From: Bastek, Brian
Sent: Thursday, July 30, 2015 9:01 AM
To: O'Connor, David A.
Subject: Grenada VI Study Work Plan

From: Bastek, Brian
Sent: Thursday, July 23, 2015 9:24 AM
To: Hodoh, Ofia
Subject: RE: FW: Grenada Manufacturing, LLC VI Work Plan
Attachments: Boring Locations.jpg; June 2015 Well Location Map.pdf; Plume Figure - Fourth Quarter 2014 GW Report.pdf

ARCADIS is requesting the US Environmental Protection Agency (USEPA) Region 4 approve the following modifications to the soil and groundwater sampling portion of the Interim Measures Work Plan (IMWP). Each of the requested changes is to an approved sampling method or procedure that is currently utilized within both USEPA and State Regulatory programs. The three requested modifications concern the hexavalent chromium method, a low volume sample volume for SVOC analysis, and use of high density polyethylene tubing. The approval of the requested modifications will enable us to implement the soil and groundwater sampling program in a more efficient and cost-effective manner.

FIGURE 4. Proposed Boring Locations

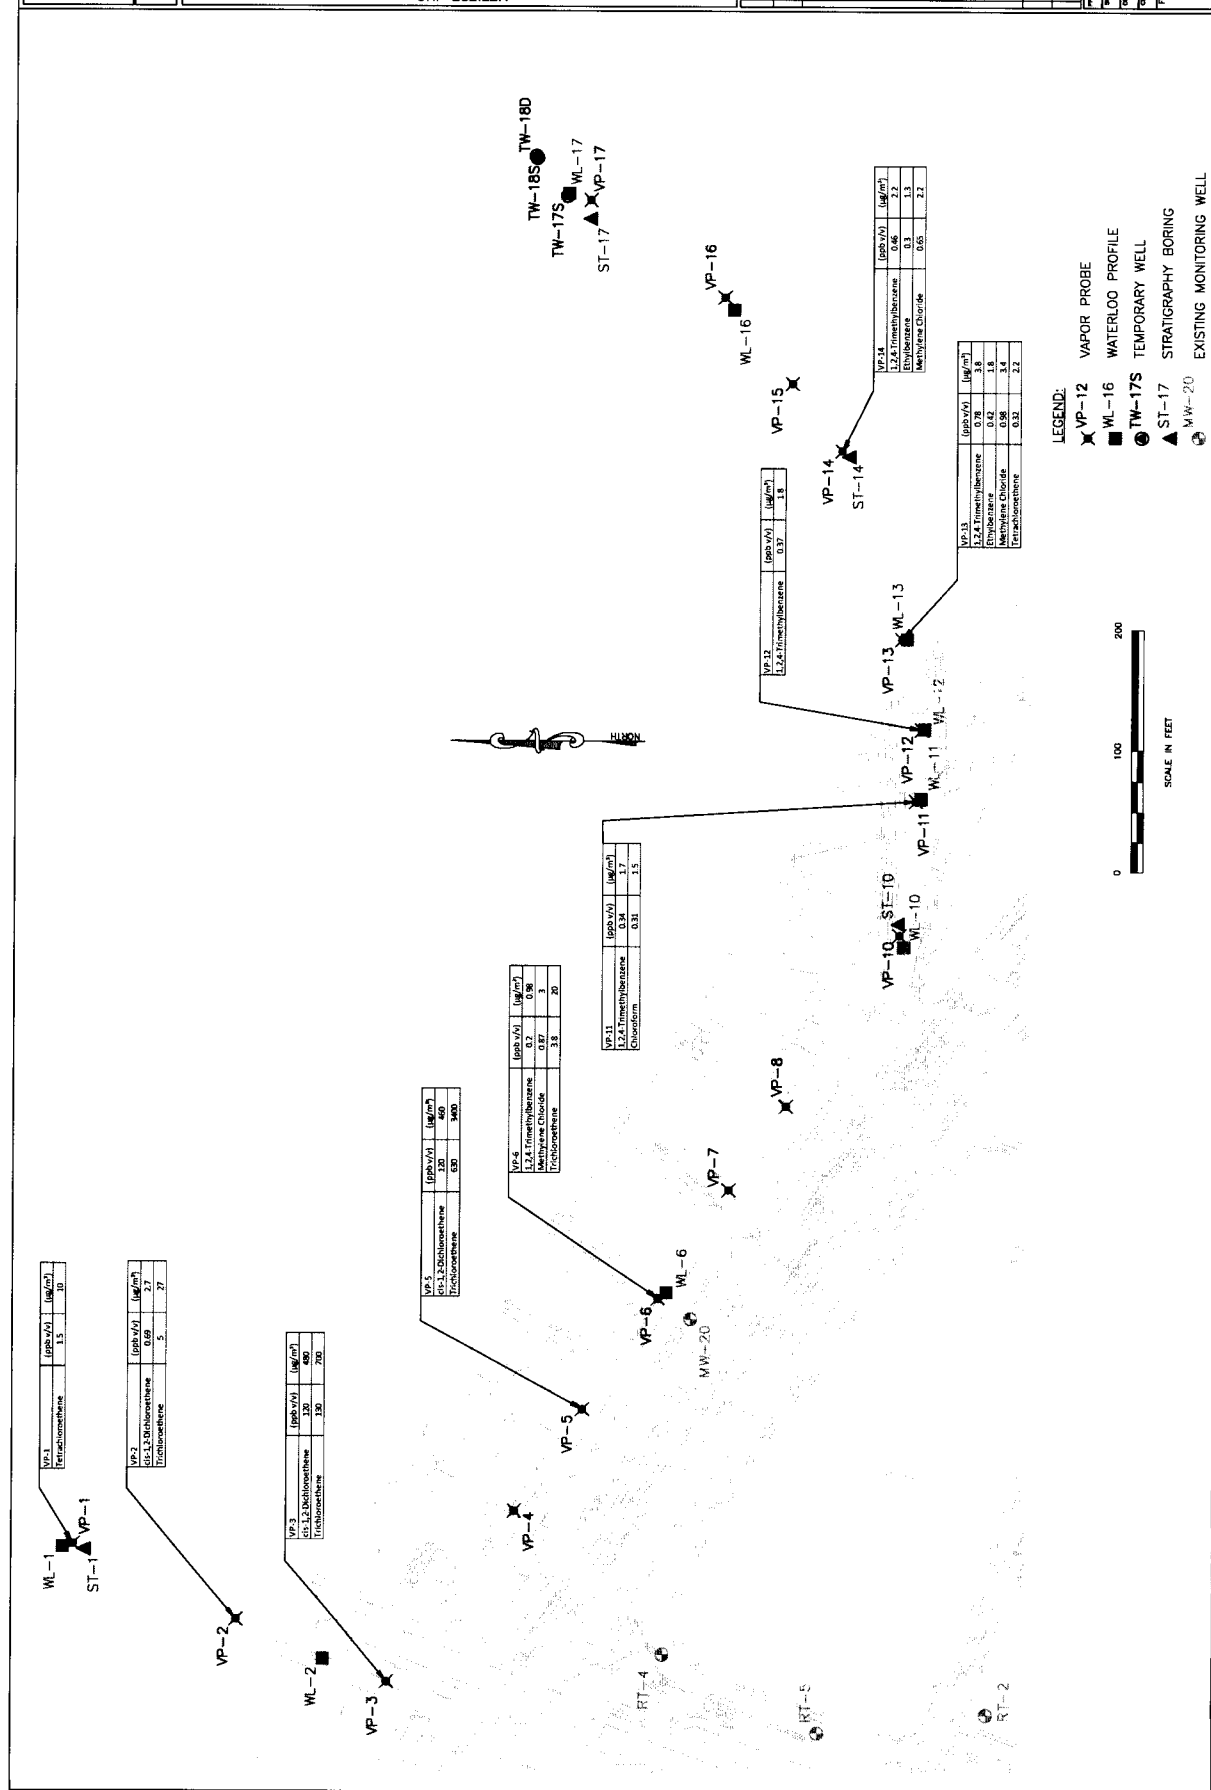
Additional borings will be installed to the east and west of VP-5 and north of VP-3 to better define the stratigraphy near these soil gas probes. Borings will also be placed in a line south of VP-5 toward the EQ Basin, and borings will be placed around the perimeter of the EQ Basin. Figure 3 shows the proposed locations for additional borings in the MW-20 Area. The actual boring locations will vary from the locations shown on Figure 3 due to field constraints and the presence of underground utilities, but the locations will generally conform to those shown in the Figure.
